# CITY OF SAN ANTONIO

RE: Verano North/ South Boulevard Plat # 080489

Re: **Verano**

**MDPP # 011-08**

**VERANO SOUTH**  
**MASTER DEVELOPMENT PLAN**  
JUNE 26, 2008

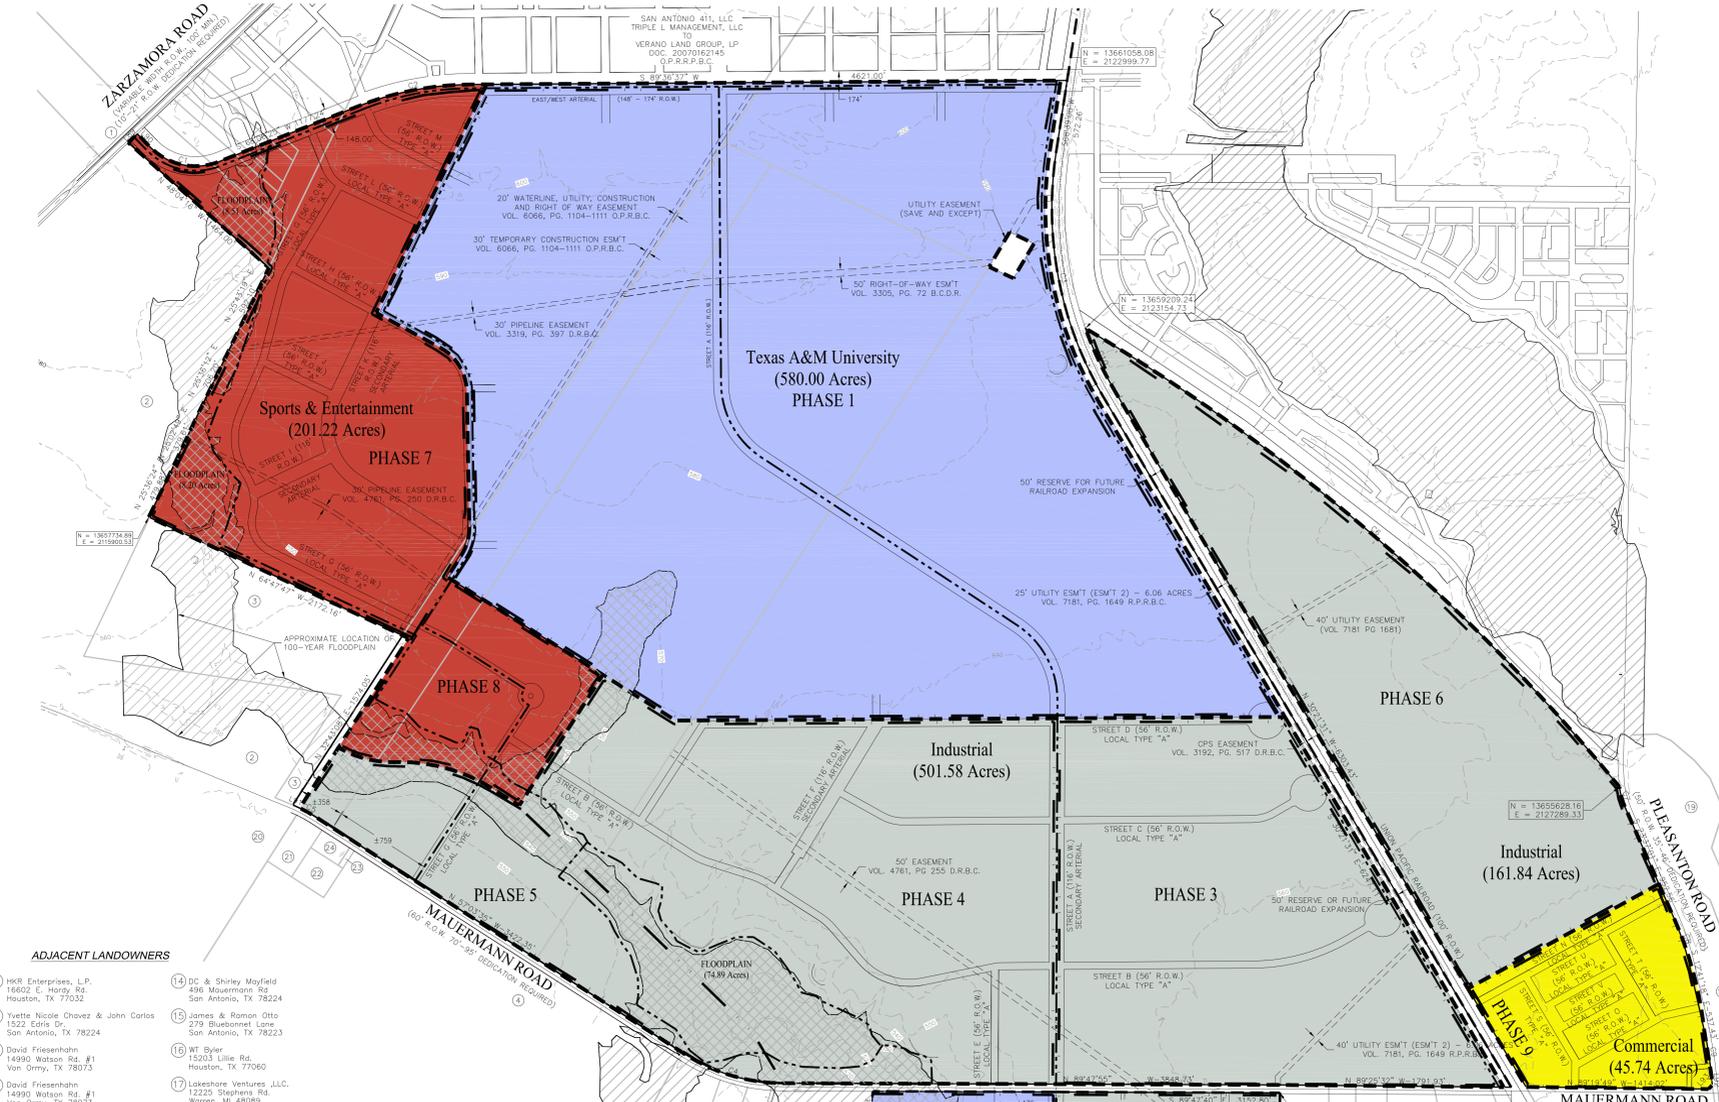
In consideration of public safety and convenience, excessive grades by reason of topography should be avoided in street layouts and arrangements. Any access and R.O.W. issues along state facilities will need to be resolved with the **Texas Department of Transportation (TXDOT)**. For information about these requirements you can contact TXDOT at 615-5814.

- The proposed transit route has been identified as a one-way circulator route,
- Travel lanes accommodating the transit function are required to be of an 11' width, and
- The effective turning radius generated by on-street parking, will be required for most transit turning movements through the development.

Additionally, please note that, in an effort to accommodate the intent of the plan, each section of the proposed transit was reviewed for its adjacent street condition, e.g., on-street parallel parking, parkland, etc., and therefore, some sections on the transit route have been proposed/approved at 10'. There are additional recommendations for reducing the adjacent parking lanes from 8' to 7' for the specific areas where the transit route is proposed.

If, in the future, it is desired to have a bi-directional transit route, the plan will need to be reviewed at that time, to identify any conflicts at specific route sections where two, 10' opposing travel lanes are proposed, without adjacent space to accommodate transit vehicles.

- The code states that narrower lane widths may be allowed upon review by the Fire Department and finding that additional access roads are provided. It should be noted however, that the Fire Department reserves the right to judge the appropriate or inappropriate nature of such access roads and that merely placing an additional alley in a plan may not meet the intent of the Form Based Development Zoning District in the UDC.

- The proposed use of narrow streets is also difficult to assess without a plan for the types and heights of structures served by such streets. Street widths must accommodate aerial ladder operations when structures extend 30' or more. As a result, the use of narrower streets will limit the heights of buildings adjacent to them and this must be considered during review.

- At this time, storm water retention is required for portions of this development that drain toward Mitchell Lake. This requirement is under review and may be removed and/or reduced prior to development. Any storm water retention and/or detention facility design shall be provided with individual subdivision plats. Any associated revisions to this MDPP shall also be required at that time.

- Because this review is based on the Form Based Development Code, a Traffic Study is not a requirement. However, should the applicant choose to voluntarily do a Traffic Study mitigation measures will not be required for Level of Service indicators reported in the Traffic Study as per UDC § 35-209 (a)(5)(3). Therefore, levels of service not traditionally accepted may be experienced in this development. It is our recommendation that at the time of platting the Traffic Study be revised to reflect the proposed geometric design of the plans being submitted.
- Intersection design will be reviewed in concurrence with the construction documents submitted at the time of platting. All Traffic control devices and pavement markings recommended will have to be justified and meet the MUTCD latest edition.

- Because this review is based on the Form Based Development Code it may not meet some of the Traffic Impact Analysis requirements of the UDC, as required in UDC § 35-209 (a)(2)(B).
- At the time of the issuance of this acceptance, only the construction design drawings for North/South Boulevard from Loop 410 to the proposed East/West Arterial have been reviewed.

- At the time of platting, street connections will be required to existing adjacent to the development, as required in UDC § 35-506(e)(2).
